U.S. Nuclear Regulatory Commission
Attn: Document Control Desk
Washington, DC 20555-0001Oyster Creek Nuclear Generating Station
Facility Operating License No. DPR-16
NRC Docket No. 50-219

Subject: Response to Draft Request for Additional Information - AmerGen Application to Revise Technical Specifications Regarding Secondary Containment Operability Requirements During Refueling

**TECHNICAL SPECIFICATION CHANGE REQUEST No. 338
"SECONDARY CONTAINMENT OPERABILITY REQUIREMENTS
DURING REFUELING"**

Oyster Creek RAI #10 Assumed Diffuse Area Building Surface Release Point

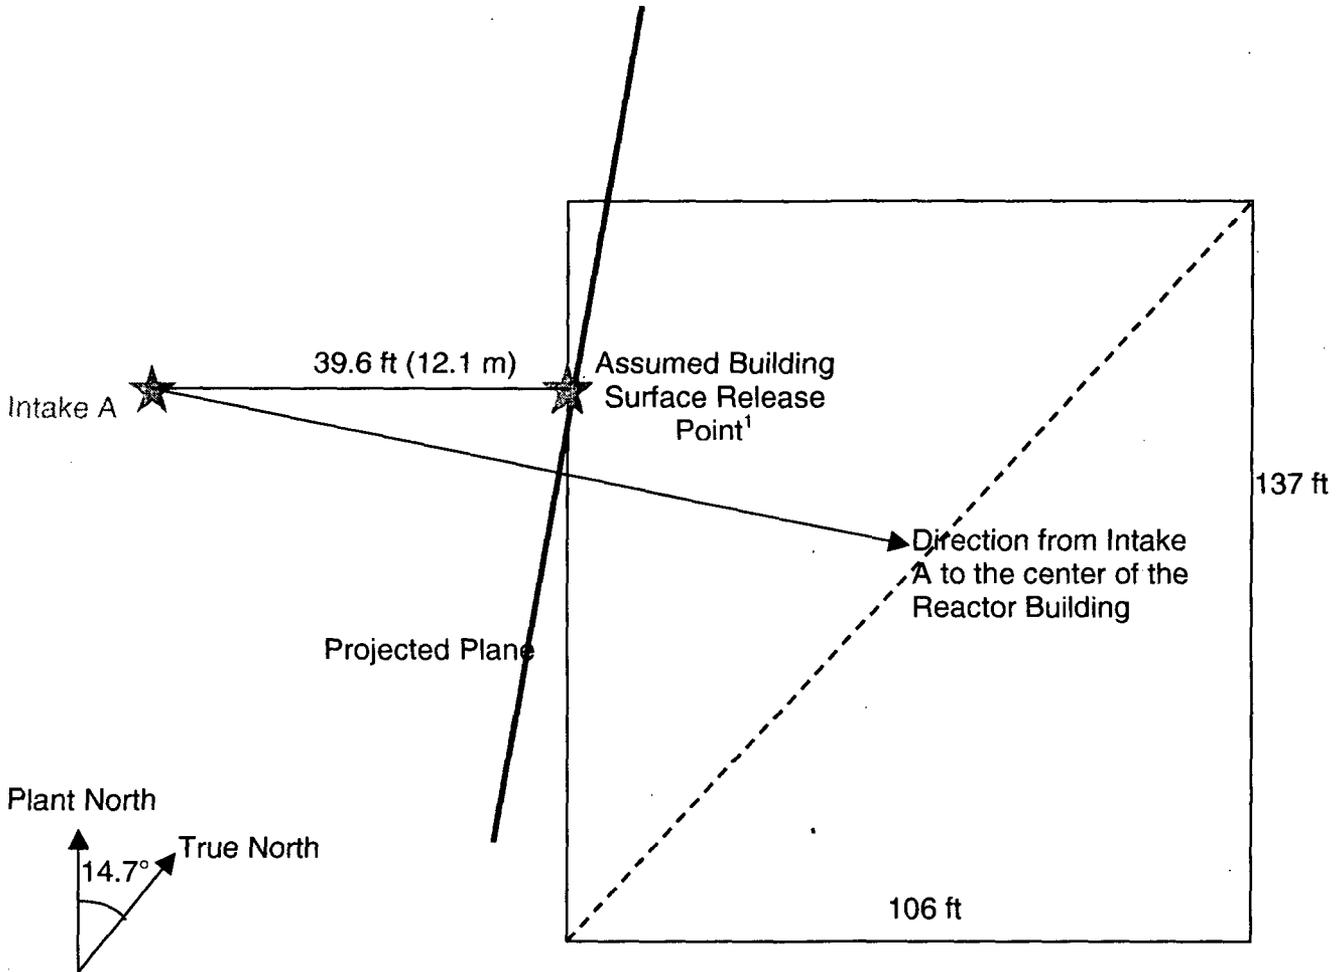
Considering this statement, please justify the use of the ARCON96 computer code to estimate the X/Q value for the Reactor Building Wall source location to the Control Room Intake A receptor point. The horizontal distance for this particular source/receptor pair is noted as 7.9 meters (25.8 feet), which is considerably less than 10 meters (as specified appropriate for use of the ARCON96 computer code in RG 1.194). Please indicate what impact this may have on the resulting X/Q values if used inappropriately.

The subject diffuse area source-to-receptor distance of 7.9 meters that was assumed in Calculation C-1302-822-E310-081 is not the closest distance from Intake A to the actual physical Reactor Building wall, but instead to the much nearer vertical planar surface projected perpendicular to the line of sight from Intake A to the center of the Reactor Building. This plane was positioned to intersect the Reactor Building at the point that minimizes the plane's horizontal distance from Intake A (as shown in Attachment G, page 5 of 6 of the Calculation). This distance is less than 10 meters, the approximate source-to-receptor distance less than which Regulatory Guide 1.194 indicates that ARCON96 may not be appropriate. However, if the X/Q for this scenario were to be recalculated by ARCON96 with a horizontal distance of 12.1 m (i.e., the distance from the closest point on the actual Reactor Building surface to Intake A, as depicted in the sketch below) in accordance with the diffuse area source method described in Section 3.2.4.5 of R.G 1.194, the resulting X/Q values would be smaller.

Scenario: Reactor Building Wall to Intake A

Direction from Intake to Assumed Building Surface Release Point:
90° from Plant North
90° - 14.7° = 75.3° from True North

¹ Per RG 1.194, Section 3.2.4.5, the release point is defined as the closest point on the building surface to the intake.
